SUBJECT: BOARD NOTIFICATION 83-109

This notification transmits the NRC staff plan to address the concerns of Dr. Ross Landsman regarding the structural adequacy of the Midland Diesel Generator Building.

MIDLAND ENERGY CENTER GWO 7020
RESPONSE TO NRC REGION III QUESTIONS
OF JULY 14, 1983 MEETING
File: 0485.16 UFI: 42*05*22*04 Serial: CSC-6792
12*32

RE: DOCKET NO. 50- 329/330
MIDLAND PLANT-UNITS 1 & 2
INDEPENDENT ASSESSMENT OF UNDERPINNING
REPORT NO. 41

V. RECOMMENDATIONS

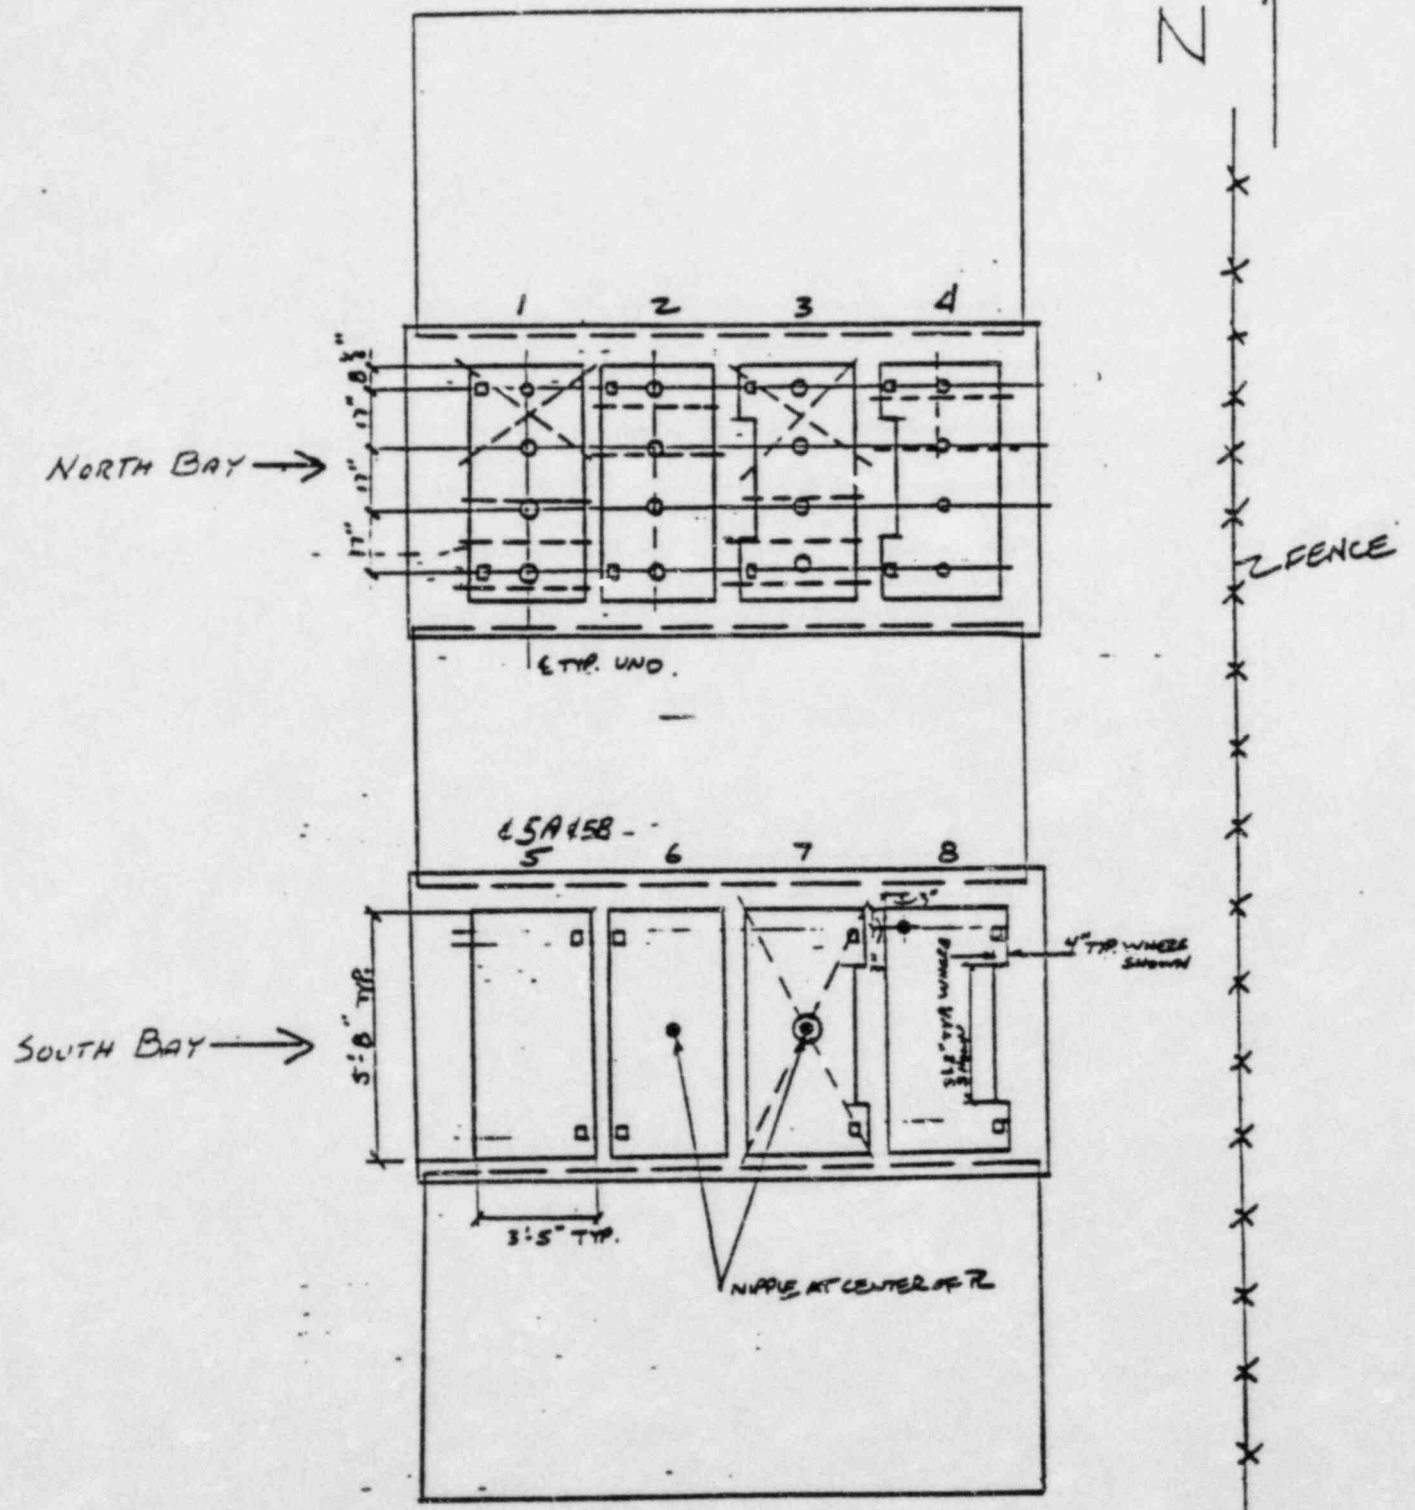
Utilization of leadwool as a form of bulkheading for pressure grouting should be kept as an option for areas where the more conventional wood bulkheading can not be utilized. There may be instances during grouting where the use of leadwool will provide the best and most reasonable means of stopping grout movement. Care will still have to be exercised to ensure that use of leadwool does not reduce the required effective bearing area of the grout pad.

An option, although not tested, that should prove equally as good as the single injection point system would be a dual injection point system (At 1/3 points down the center of plate). This system would use two grout pumps both of which are pumped either simultaneously in a manner so as not to form air pockets/bubbles as noted in Section III D of this report.

Grouting pressure should be kept near the minimal required to obtain grout flow through the air vents. To avoid possible plate bowing or excessive bracing of plates, slow stroking of the handpump to eliminate impulse loading should be utilized.
